Access Compliance Report

Public Rights-of-Way

Intersection ID: N/A	Main Street: INDEPENDENCE_RD	Cross Street: N/A	Location: E
ADA ID: 3ECF1CF19273	Ramp Type: Perp	Initial Pass/Fail: Fail	Overall Compliance: No
		Severity Score: 25

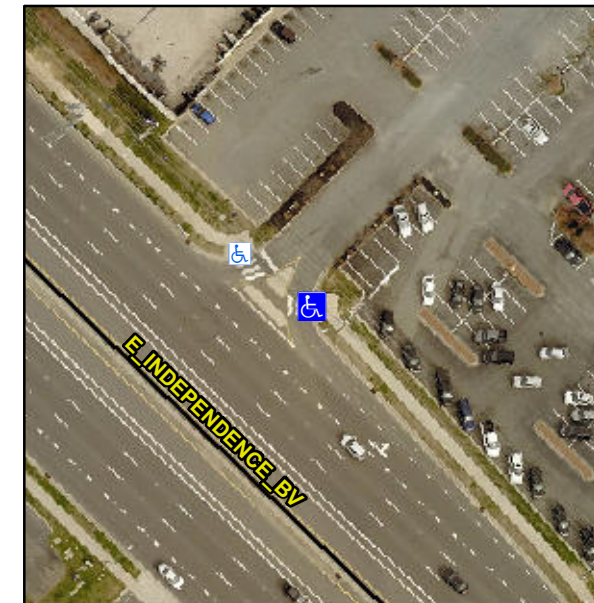
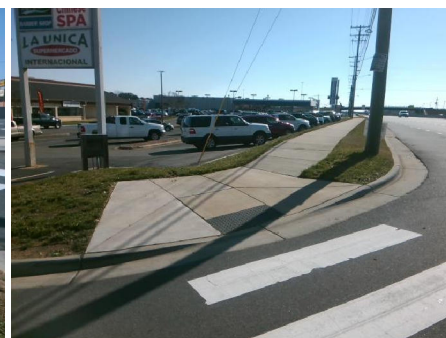
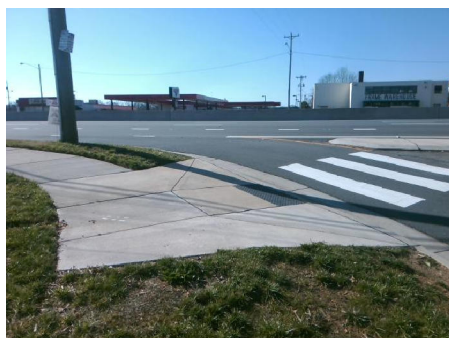
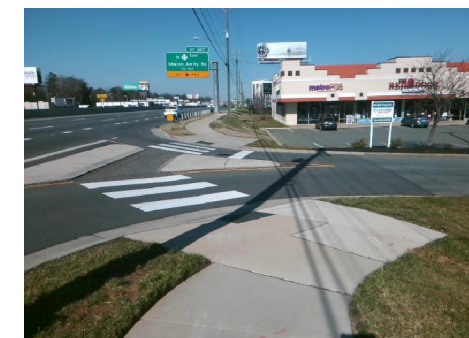
Not Found, R304.5.3

Compliance	Description	Data	Compliance	Description	Data
N/A	Ramp Length (in)	73.0	Yes	Ramp Slope (%)	5.7
Yes	Ramp Width (in)	48.0	No	Ramp XSlope (%)	10.2
N/A	Flare Type LT	N/A	N/A	Flare Type RT	N/A
N/A	Flare Slope LT (%)	N/A	N/A	Flare Slope RT (%)	N/A
N/A	Flare Traversable LT?	N/A	N/A	Flare Traversable RT?	N/A
N/A	Landing Length (in)	N/A	N/A	DWS Provided?	N/A
N/A	Landing Width (in)	N/A	N/A	DWS Contrast?	N/A
N/A	Landing Slope (%)	N/A	N/A	DWS Length (in)	N/A
N/A	Landing X Slope (%)	N/A	N/A	DWS Full Width?	N/A
N/A	Landing Curb? (Y/N)	N/A	N/A	DWS Offset (in)	N/A
N/A	Shared Landing?	N/A			
N/A	Gutter Ponding?	N/A	N/A	Gutter Slope (%)	N/A
N/A	Gutter Lip Ht (in)	N/A	N/A	Gutter X Slope (%)	N/A
N/A	Painted X Walk1?	Yes	N/A	Painted X Walk2?	N/A
	X Walk 1 Direction	To NW		X Walk 2 Direction	N/A
N/A	X Walk 1 Width (in)	119.0	N/A	X Walk 2 Width (in)	N/A
	X Walk 1 Slope (%)	6.8		X Walk 2 Slope (%)	N/A
	X Walk 1 X Slope (%)	9.9		X Walk 2 X Slope (%)	N/A

Remove & Replace Entire Ramp.
